' B	UNITED STATES ARTES AUG 3			5 OMB NO. 1004-0135 Expires: July 31, 2010	
SUNDRY NOTICES AND REPORTS ON WELLS			5. Lease Serial No. NMNM0405444A		
Do not use this form for proposals to drill or to re-enter an abandoned well. Use form 3160-3 (APD) for such proposalsRECEIVED			6. If Indian, Allottee or Tribe Name		
SUBMIT IN TRIPLICATE - Other instructions on reverse side.         1. Type of Well         Image: Submit Control of Well         Image: Submit Co				<ul> <li>7. If Unit or CA/Agreement, Name and/or N</li> <li>8. Well Name and No. TODD 22D FED 4</li> </ul>	
3a. Address 333 WEST SHERIDAN AVE OKLAHOMA CITY, OK 7310	b. Phone No. (include area code Ph. 405-228-8429			Exploratory DELAWARE

### Temporary Abandonment of Wells on Federal Lands Conditions of Approval

# Todd 22D Fed 4

Attached: Current and Proposed Wellbore Schematics.

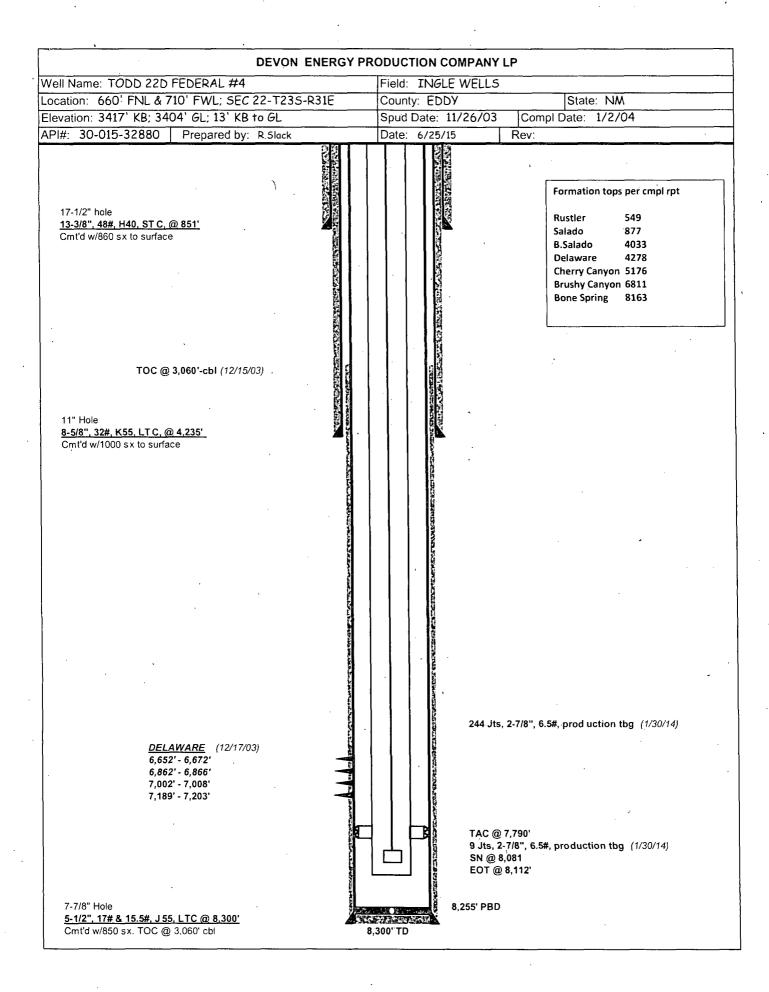
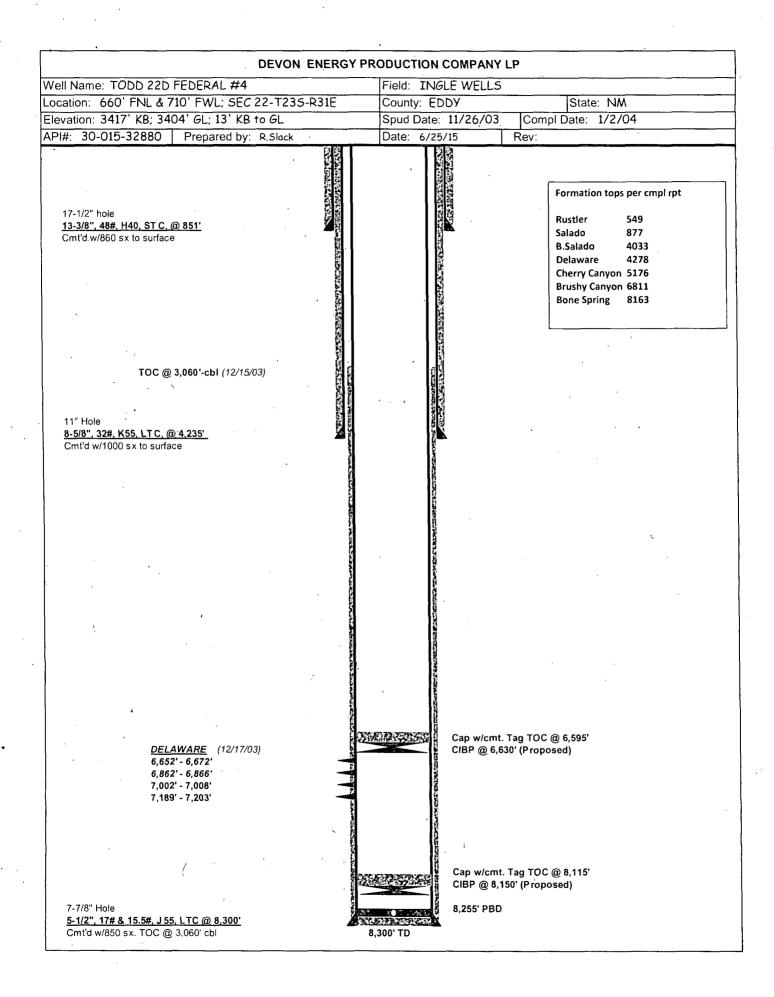
# 1. Operator shall set a CIBP at 6,602' (50' above top most perf) and <u>place 170' Class C</u> <u>cement on top.</u>
